RE: OBJECTION to Iron Creek Exploration Drilling Project, Salmon-Challis National Forest

Here is an Objection from WildLands Defense (lead Objector), Alliance for the Wild Rockies, Native Ecosystems Council and Yellowstone to Uintas Connection on the Iron Creek Exploration Drilling Project.

Final EA and Draft DN/FONSI: <https://www.fs.usda.gov/project/?project=60392..gov>

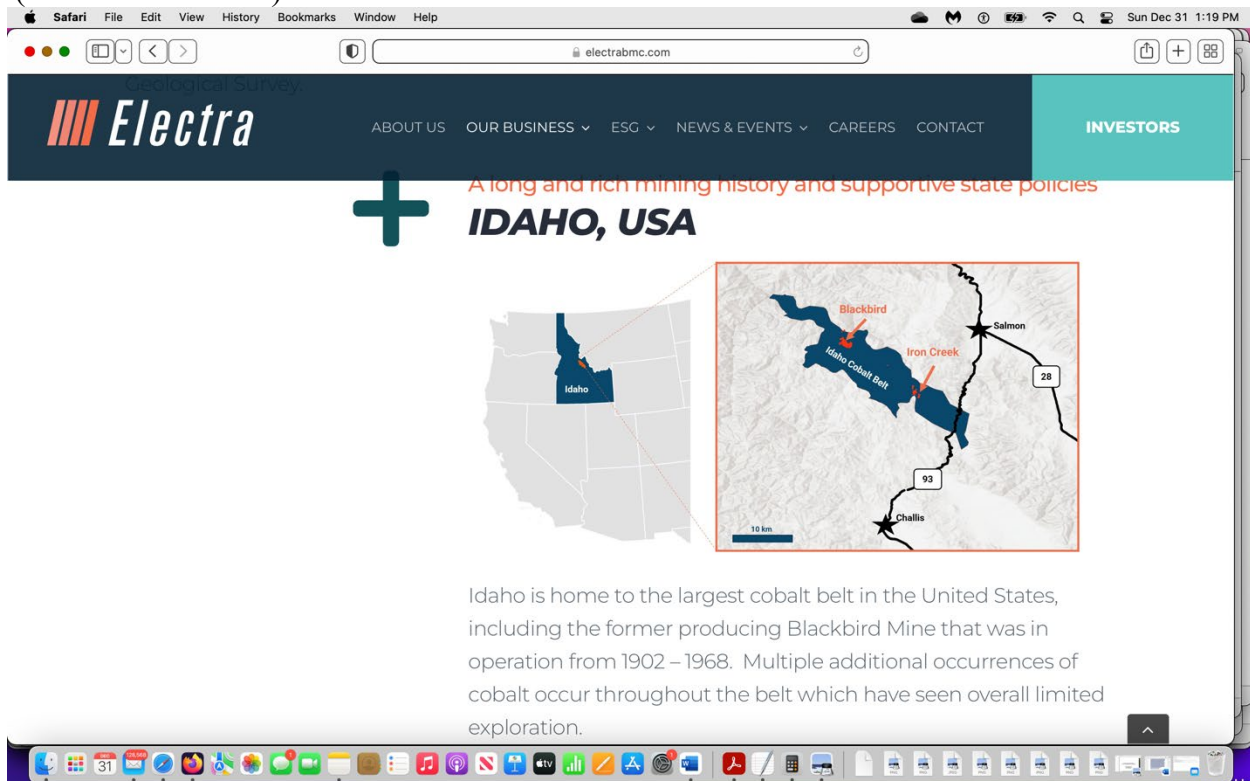
We Object that there is not adequate baseline data and information provided on the location and ecological condition of springs, seeps, intermittent drainages and their flows in this area that could be impacted by 91 drill sites with 6 holes per site and horizontal drilling (without controls on how far that will extend or how deep drill holes will go) , nor cultural and historical resources; no mapping and analysis of water quality and quantity including flows and any changes in flows over time or of ecological conditions in all riparian zones; no analysis of ecological conditions in all terrestrial and aquatic systems; no information on the shallow or deep groundwater conditions; no information on the amount of mining exploratory drilling and drilling in associated with any past mining activity that has taken place in this landscape; and other gaping information deficiencies. This is despite both new road bulldozing, bulldozing of over 11 miles of closed “temporary” roads, the proximity of drill pads to riparian areas (including 2 drill sites right inside RHCAs). There is also no careful mapping of all riparian and mesic sites which may have high water tables. There is no analysis of the type of springs that are present, and no assessment of if they are dependent on deeper groundwater, snowmelt information and other essential baseline data. Moreover, BLM never explains the situation with the closed roads. Were these closed and supposed to be rehabbed for watershed and species protection following a previous mining exploration bout? Or were they built for logging/deforestation projects? If this is the case, doesn’t this destroy any “mitigation” that was claimed to accompany that rehab?

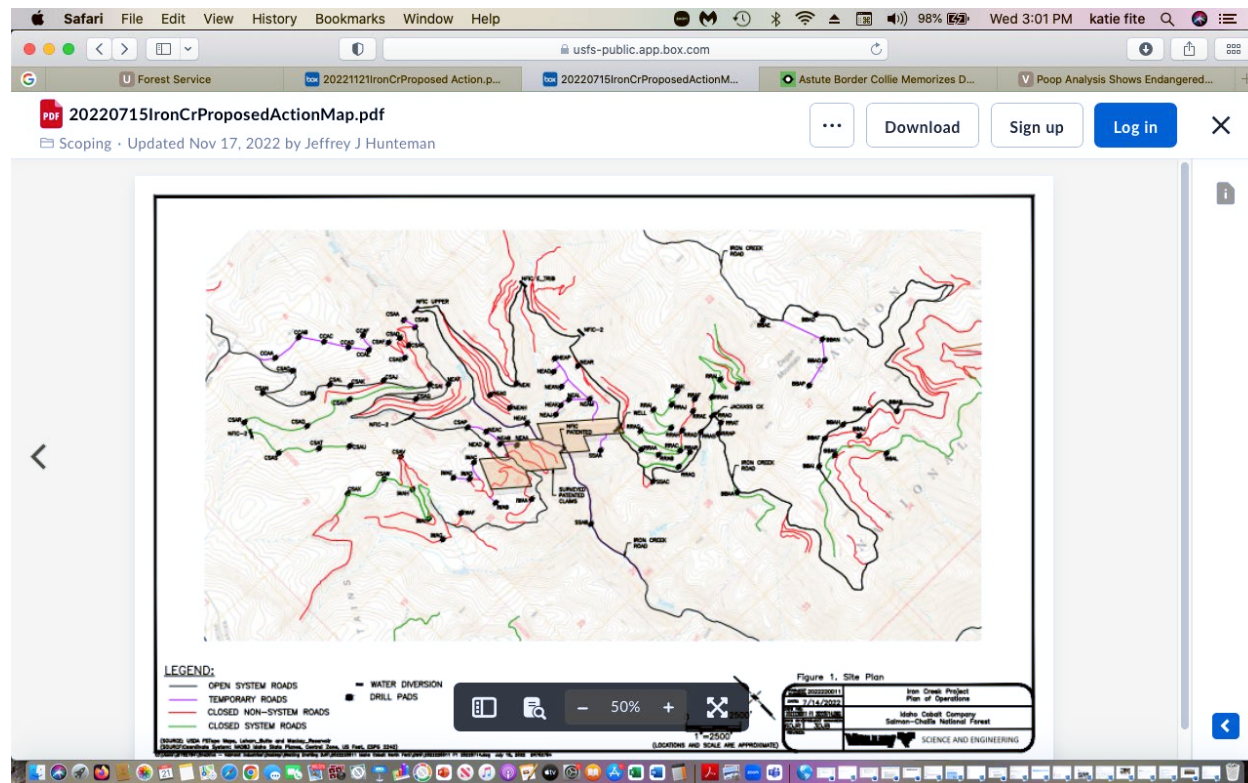
Project mapping shows the activity will massively tear up, de-stabilize soils and expose soils to extensive erosion in wind and water over a large land area. These impacts will be permanent and irreversible. We Object that the USFS has not provided necessary visual, erosion, and other analyses necessary to understand the full scale of adverse impacts.

In the above mapping from the USFS, the reddish colors are very difficult to distinguish. Please provide much clearer mapping, and detailed information on the current status of all routes – new, old, closed, not closed. We Object to the failure to address significant concerns about route proliferation, road densities, how opening closed routes undermines any past mitigation for projects, compliance with travel plans pr route closures the number and location of unauthorized routes in the RD, etc. The SCNF released an initial Moose Fire report, and there are a huge number of unauthorized routes in that fire area - and this comports with our observations across much of the SCNF. This bodes poorly for the FS being able to close routes and gashes bulldozed as part of the exploration project – and is another reason why helicopter drilling must be conducted. We Object to the failure to effectively examine and control significant road-route-related environmental conflicts.
